802.3dj D1.4 Comment Resolution Logic Track

Gary Nicholl (Cisco), Logic Track Lead Editor
Eugene Opsasnick (Broadcom), Logic Editor
Matt Brown (Alphawave Semi), 802.3dj Chief Editor

- This slide package was assembled by the 802.3dj editorial team to provide background and detailed resolutions to aid in comment resolution.
- Specifically, these slides are for the logic track comments

Table 172-4—PCS stateless decoder rules

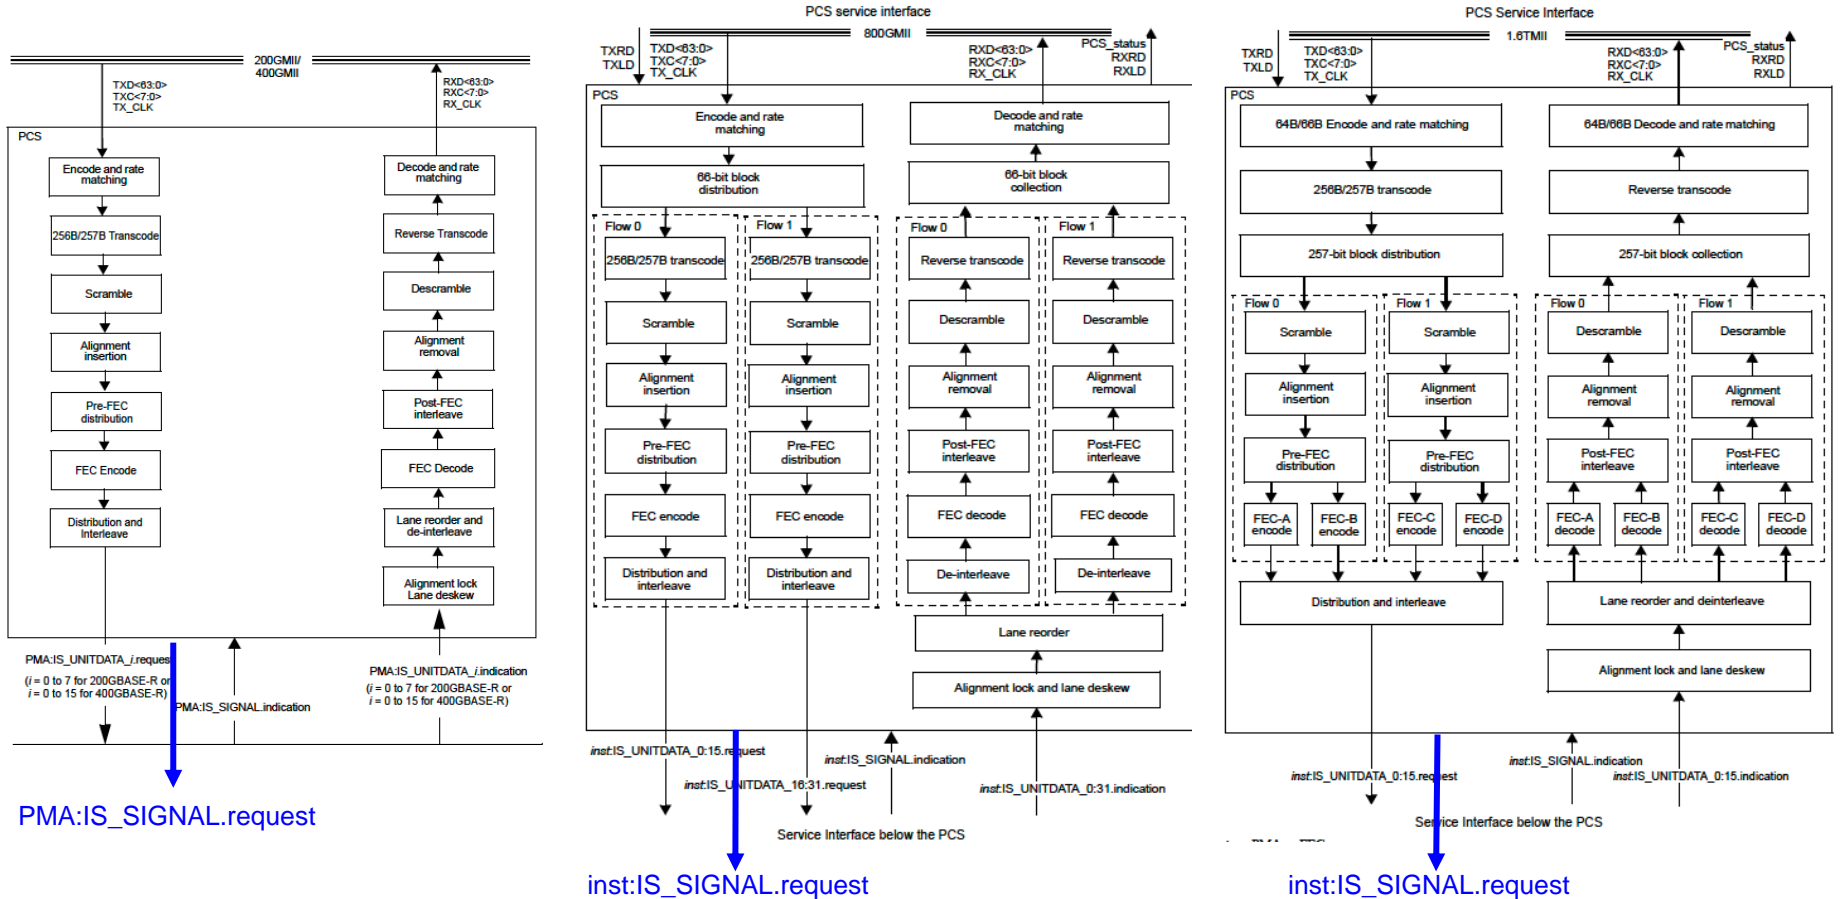
Cl 119 SC 119.2.5.8.2 P166 L15 # 239
Ran, Adeo Cisco
Comment Type T Comment Status D PCS encode/decode

The stateless decoder assumes that the received data represent valid Ethernet data and does not check it for valid frame structure, unlike the State-diagram decoder.

This should be emphasized for readers familiar with the original decoder defined in Clause 119 to prevent surprises. For example, validation suites may check the PCS with data that is not valid Ethernet and expect it to reject it.

The suggested remedy applies to this subclause (119.2.5.8.2) and to 175.2.5.9. It should also apply to 172.2.5.9.2, but it is currently not in the draft and may be out of scope.

Add a NOTE at the end of 119.2.5.8.2:

NOTE—The stateless decoder relies on the Reed-Solomon decoder for error correction and marking, and unlike the state-diagram decoder, it does not check the validity of Ethernet frames.

PROPOSED ACCEPT IN PRINCIPLE.

The stateless PCS decoder is defined in CL 172 and there are references to it from CL 119 and CL 175. The best place for this note would be in CL 172 with the decoder definition itself, and then notes in 119 and 175 should not be necessary.

Add a note to 172.2.5.9 with editorial license something like:

"NOTE- The stateless decoder does not detect all packet framing errors that the state-diagram decoder can detect. It relies on the RS FEC decoder for error correction and marking as well as the MAC ethernet frame FCS check for frame reliability."

Add note after table 172-4.

Table 176-6—inst:IS_SIGNAL.request(SIGNAL_OK) generation

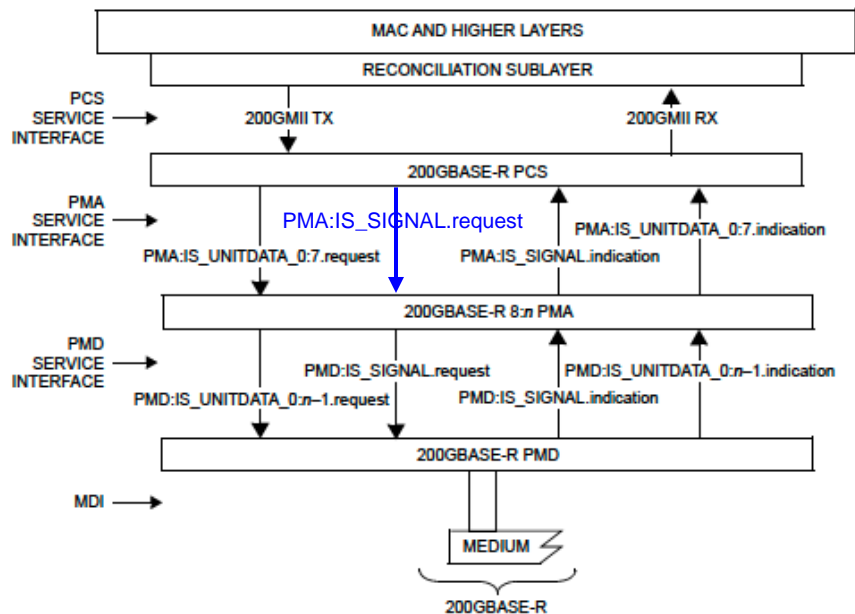
Comment #251 - PMA IS_SIGNAL Generation

~~^e When PMA_IS_SIGNAL.request input is not present. For example, when the sublayer above the PMA is a PCS or DTE XS.~~

PMA:IS_SIGNAL.request (from the sublayer above the PMA) can come from:

- Another PMA
- AUI
- PCS (newly added input)
- DTE XS (newly added input)

inst:IS_SIGNAL.request generation is more clear and consistent.

Figure 116-2—200GBASE-R inter-sublayer service interfaces

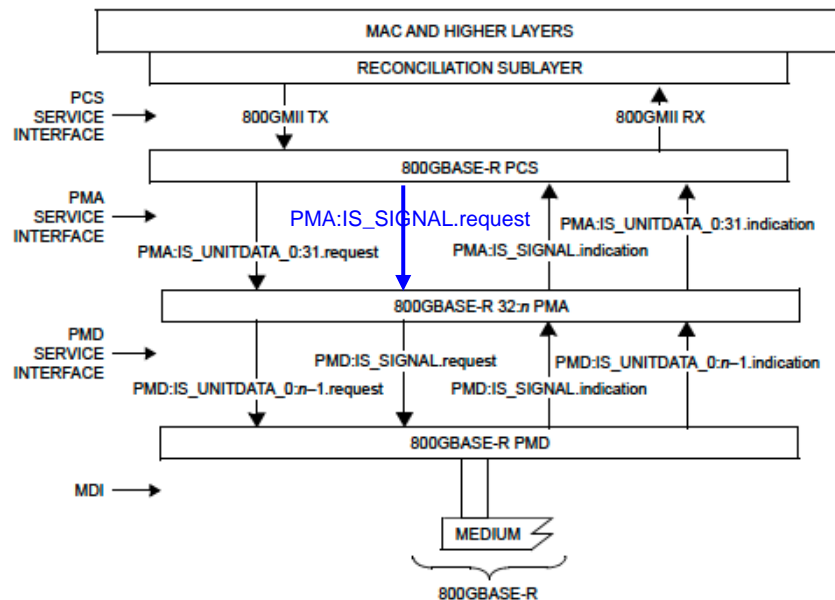
Comment #236 - Example overview figures for 200G and 800G

Figure 174-3—Inter-sublayer service interfaces for a 1.6TBASE-R PHY and 1.6TMII Extender

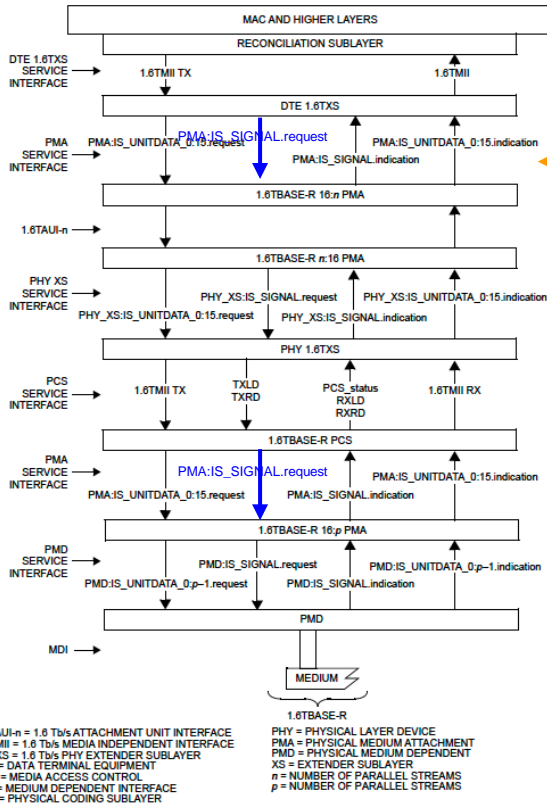
Comment #236 - examples with extender

Fig. 174-3 is a typical xBASE-R PHY with extender (Copper/IMDD PHYs).

- IS_SIGNAL.request added to both DTE and PCS Tx outputs

Figure 177-4—Convolutional interleaver

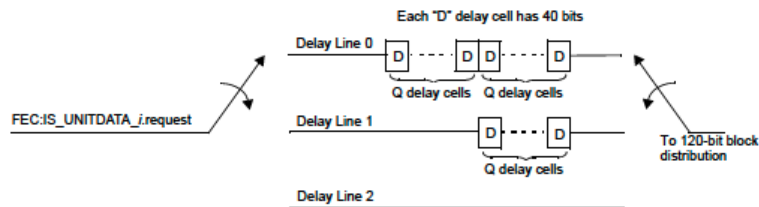
The relationship between the position of the input and output switches in Figure 177-4 is not defined.

Add the following sentence at the end of the paragraph: "The input and output switches are always aligned to the same row."

PROPOSED REJECT.

It is not required to keep the input and output switches aligned to the same row.

Figure 184-4—Convolutional interleaver

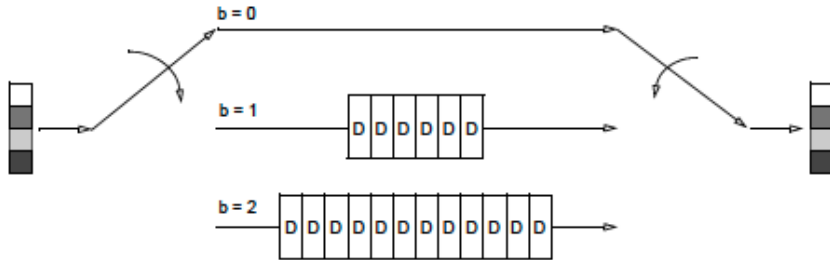
184.4.5: Convolutional Interleaver description

Part a) Input and Output switches are always aligned to the same row.

Is this not necessary?
